Optimization Review Naval Base Kitsap OU-1

NAVAL BASE KITSAP OU-1
KEYPORT, WASHINGTON

Report of the Optimization Review
Site Visit Conducted at Naval Base Kitsap on
December 3, 2012

FINAL REPORT
August 2, 2013

Figure 4-2
Risk and Compliance Long-Term Monitoring
Sampling Locations at OU 1

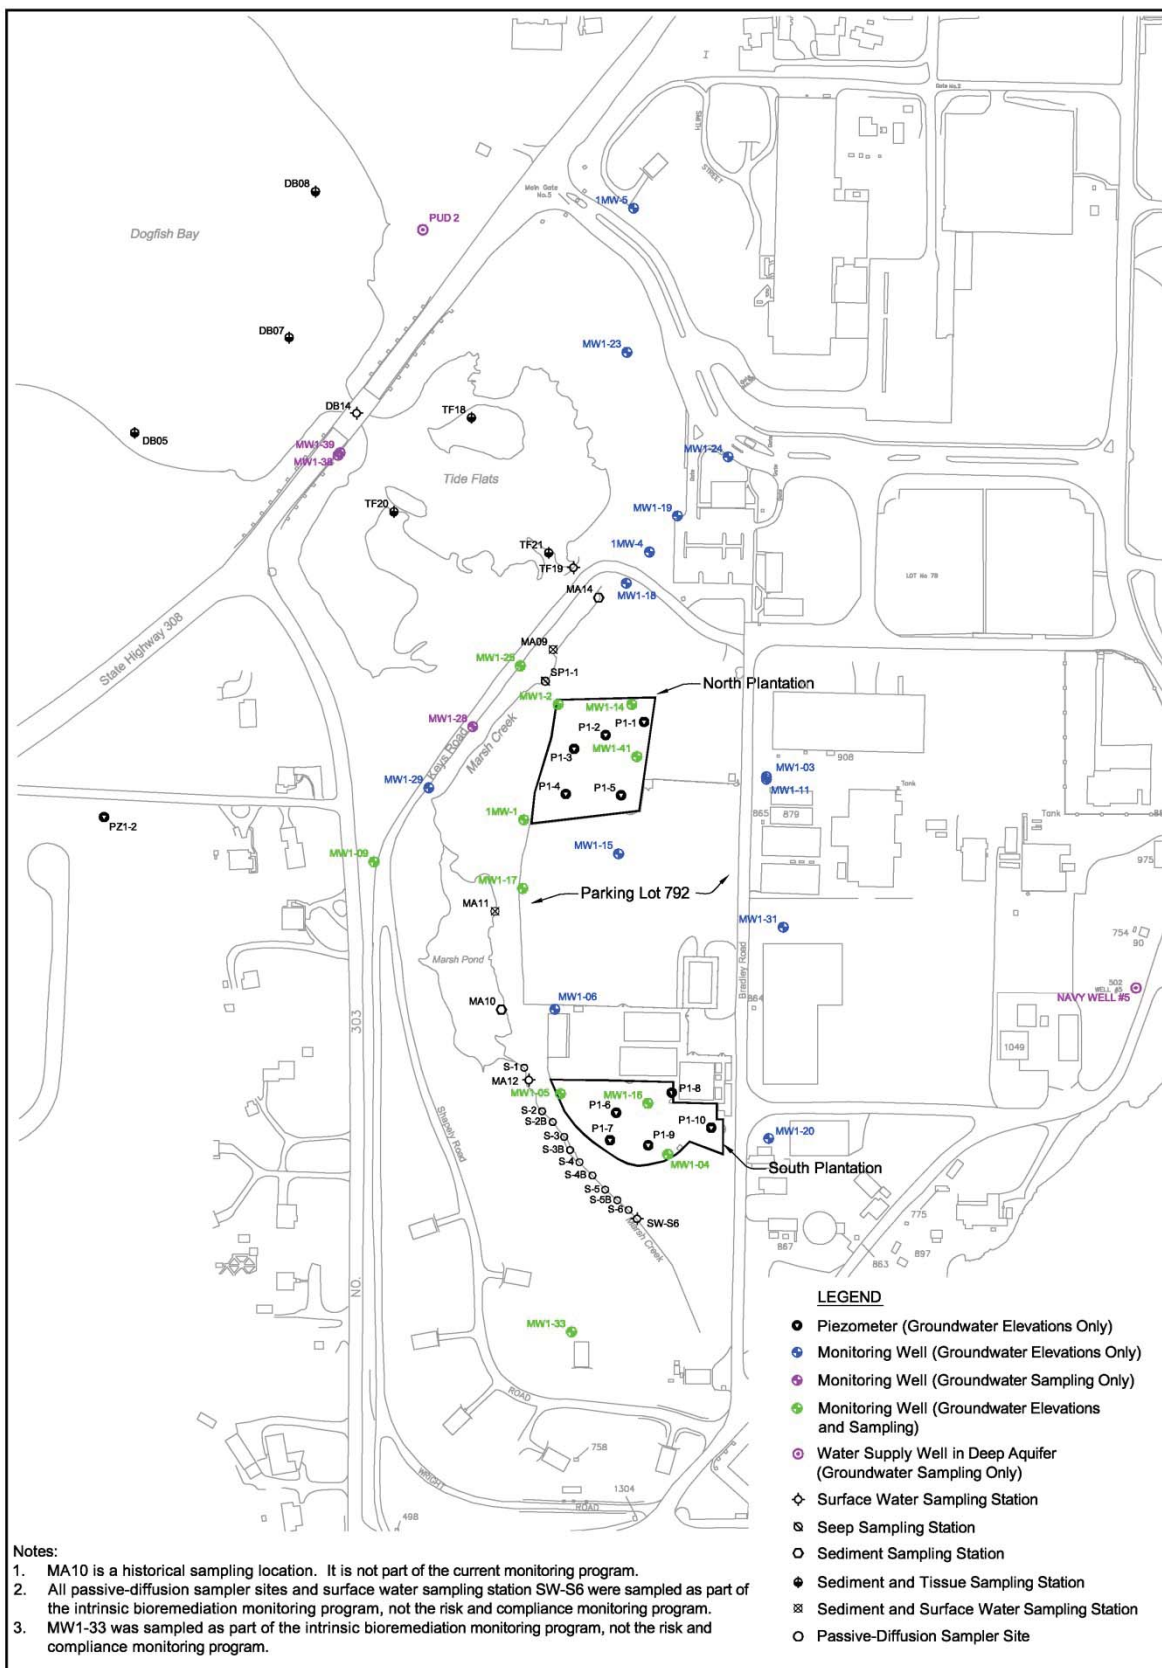
Surface water sampling locations are illustrated on Figure 4-2 from the Third Five-Year Review. This figure is provided in Attachment A of this report. TCE and vinyl chloride are routinely detected at surface water sampling location MA-12 (immediately upstream of the marsh pond) above the remediation goals of 56 µg/L for TCE and 2.1 µg/L for vinyl chloride. Over the past 5 years, TCE concentrations at this

Figure 6-3
CAH Contaminant Zones in the Upper Aquifer

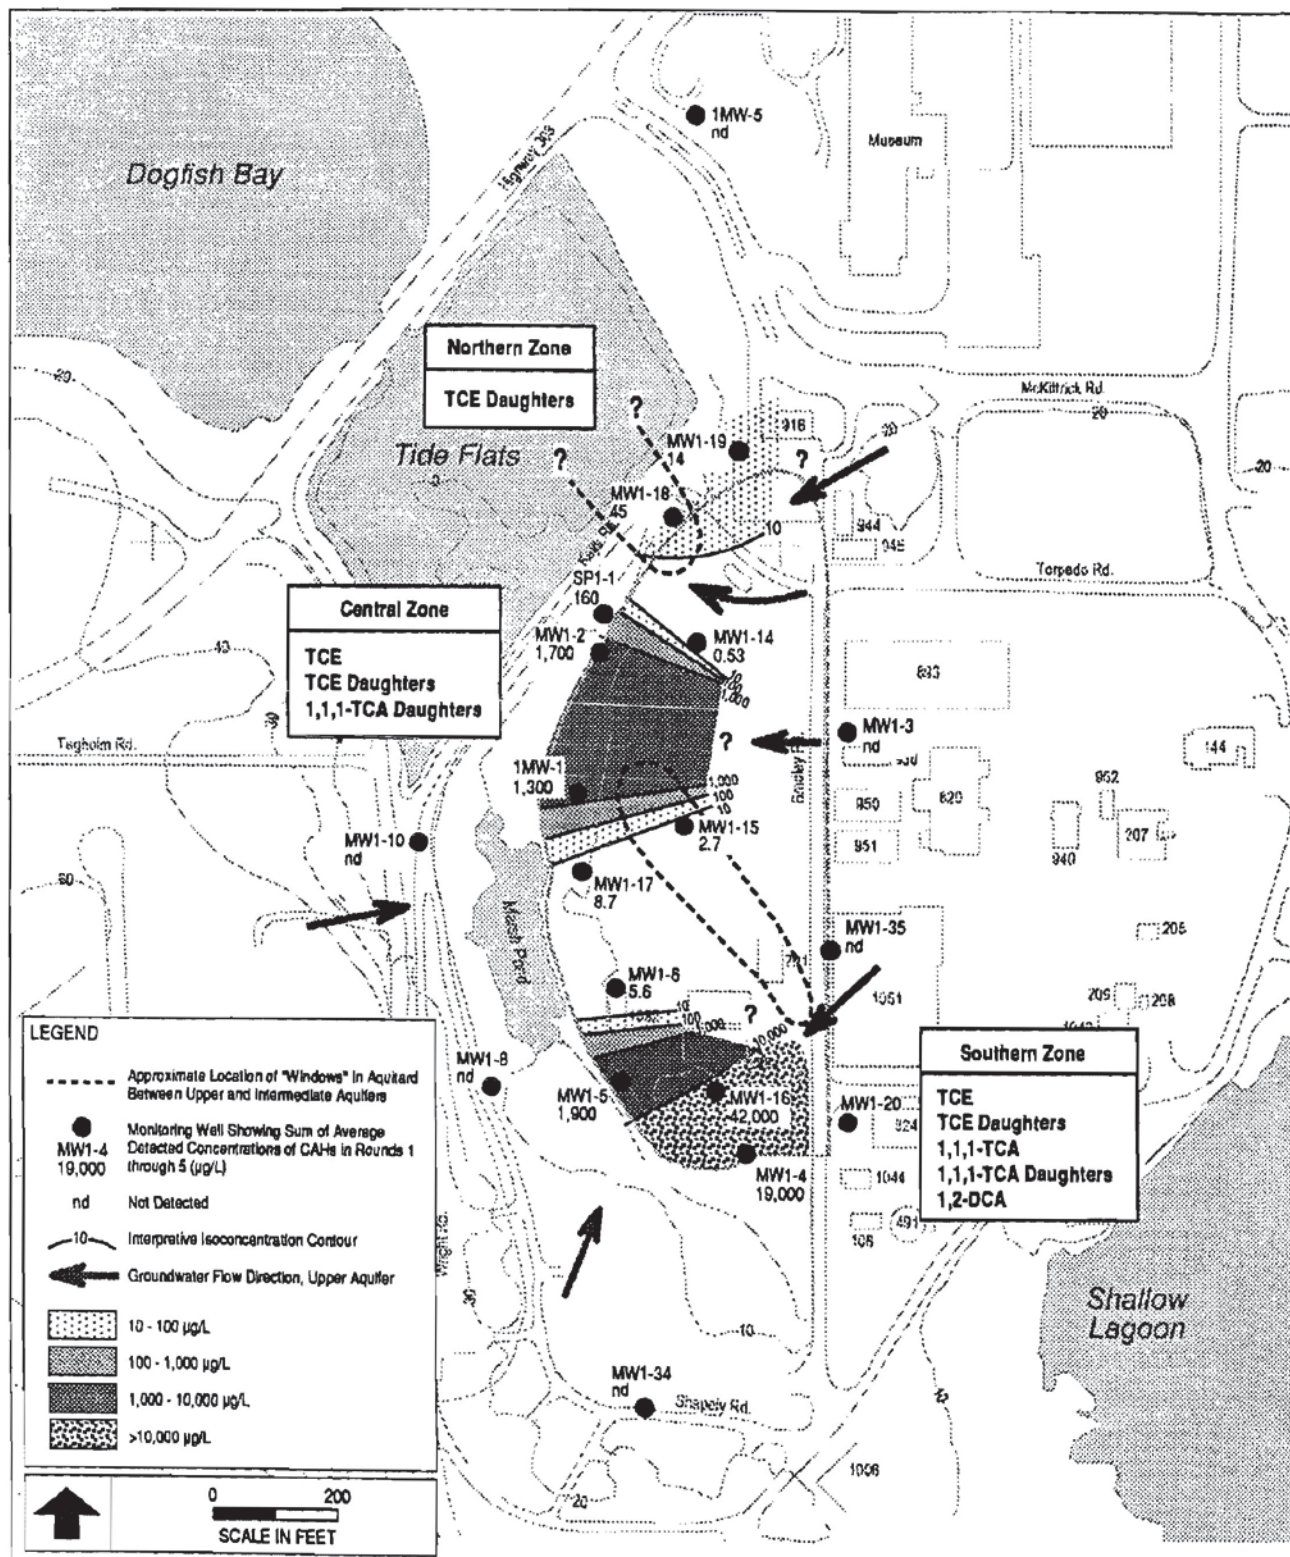
Figure 6-3 of the Data Assessment Report, which is included in Attachment A of this report, presents the magnitude (average over five rounds of sampling) and distribution of VOC contamination at various locations in the upper aquifer prior to the September 1998 ROD. VOCs shown in this figure include the following:

MW1-4 TCE cis-1,2-DCE and Vinyl Chloride Concentration Trends

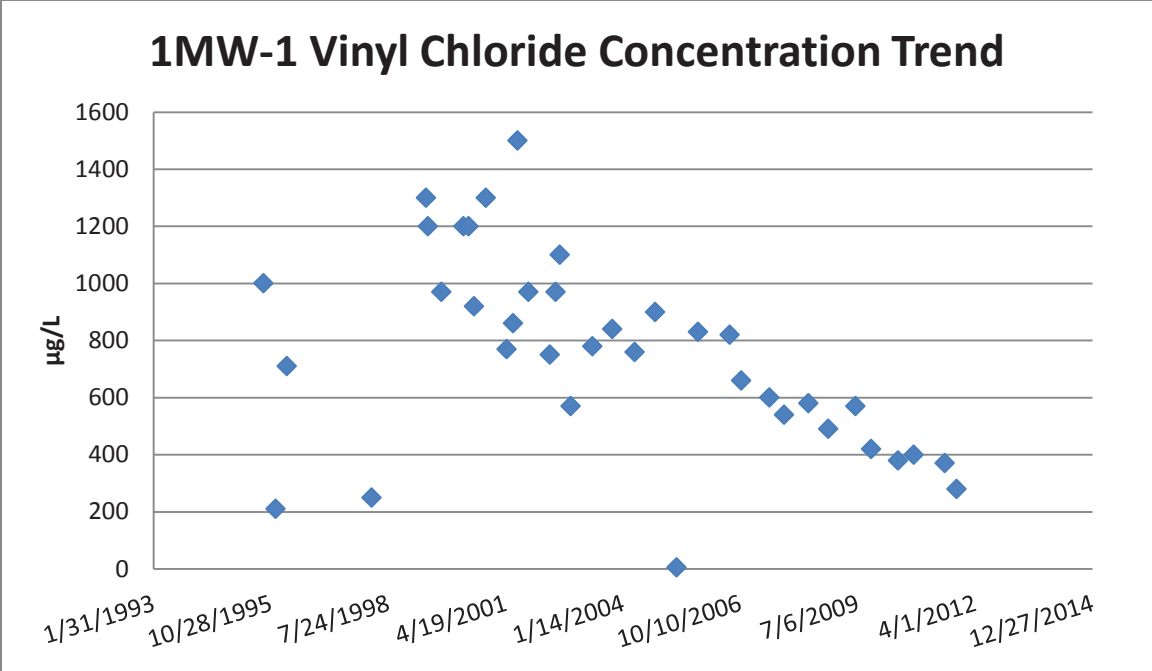
Contaminant concentrations in the upper aquifer in portions of the southern landfill (near MW1-4) remain orders of magnitude above cleanup standards, with seasonal fluctuations and no clear evidence of a decreasing trend. Contamination appears to be more widespread in the southern landfill than the northern landfill, but it is unclear how much of the contaminant extent is due to wide-spread source material and how much is due to contaminant migration in the dissolved phase. Contaminant concentration trends suggest the potential for significant contaminant mass to be present near or above the water table that provides an ongoing source of dissolved contamination to groundwater.
